Intel[®] StrongARM[®] SA-1100 Microprocessor

Specification Update

May 1999

Order Number: 278105-012

3. DRAM Single-Beat Transactions: Figure 10-3

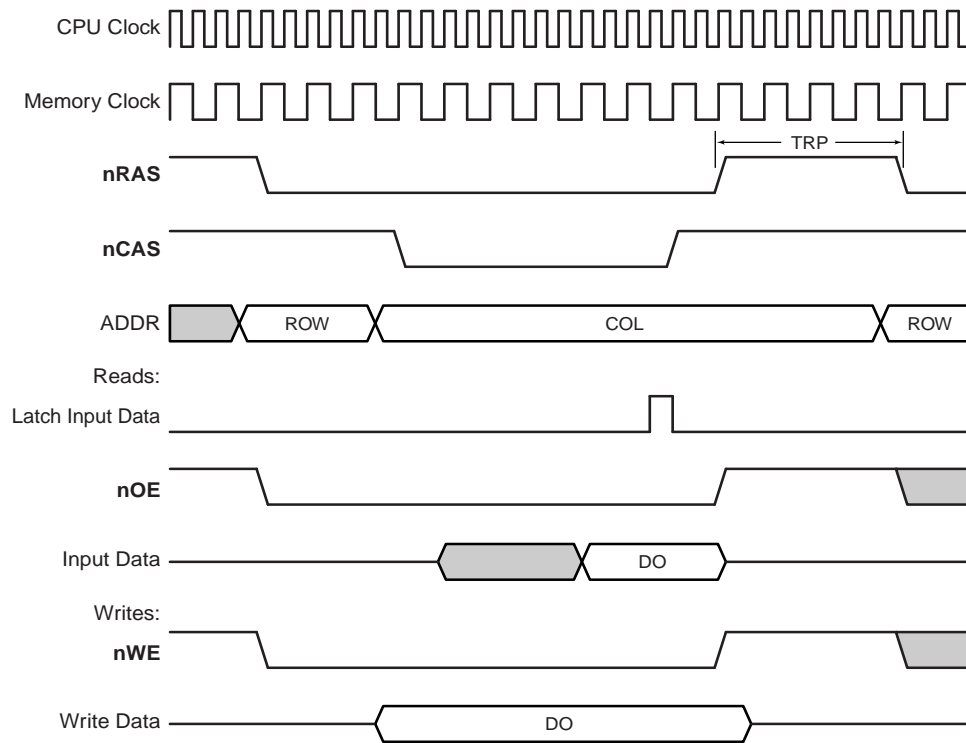
Figure 10-3 replaced with the following figure:

Contents of DRAM register fields:

last ← time → first

MDCAS1 = 11 0001 1000 11000 (binary) MDCAS0 = 0110 0011 0001 1000 1100 0110 0000 0111 (binary)
MDCNFG:TRP = 4 MDCNFG:CDB2 = 1 TDL = 00

6. **Big and Little Endian DMA Transfers: Figure 11-2**

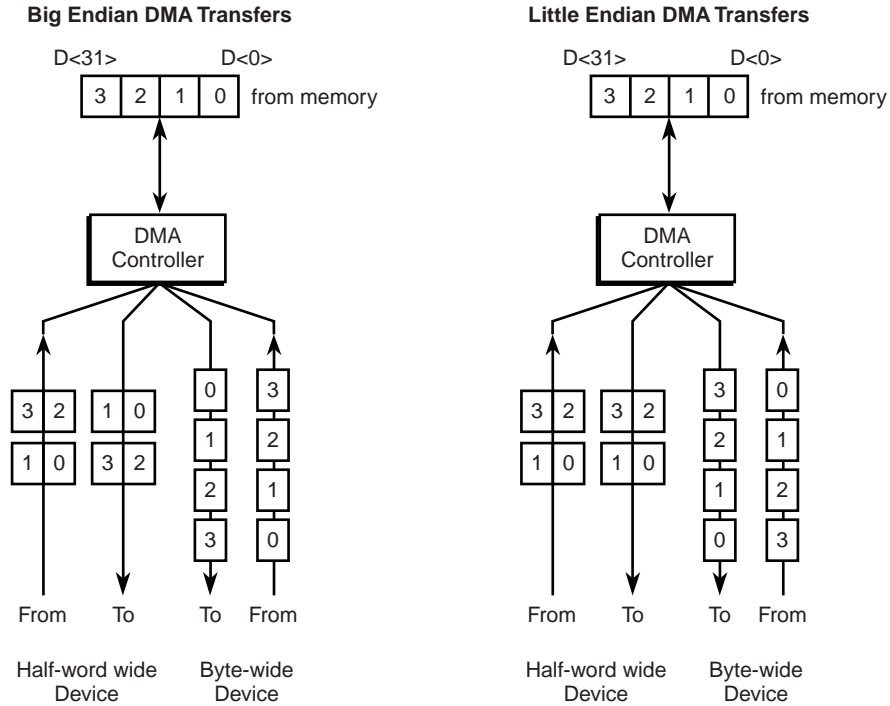
Figure 11-2 replaced with:

8. SA-1100 Functional Diagram: Figure 2-2

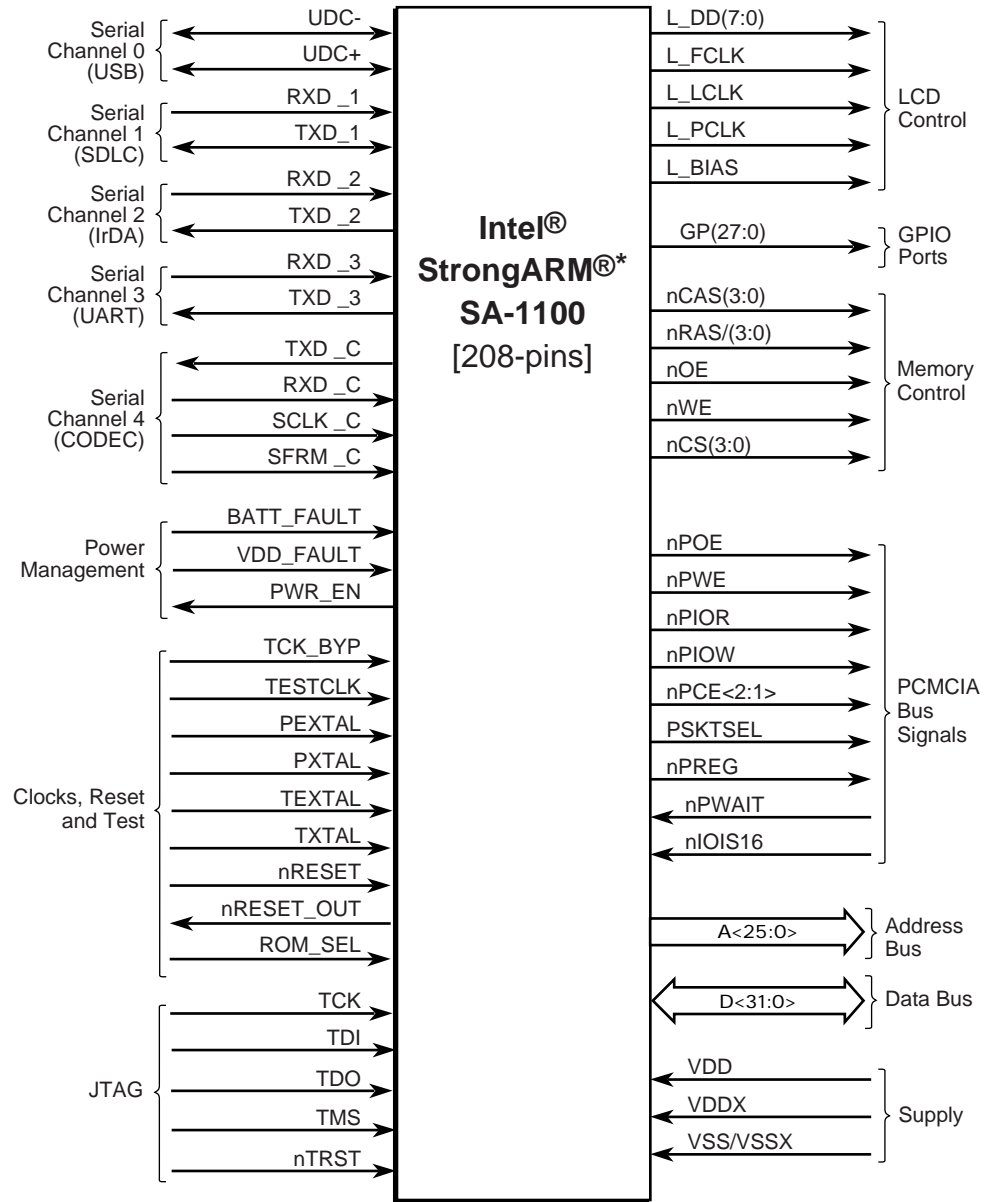
Figure 2-2 replaced with:
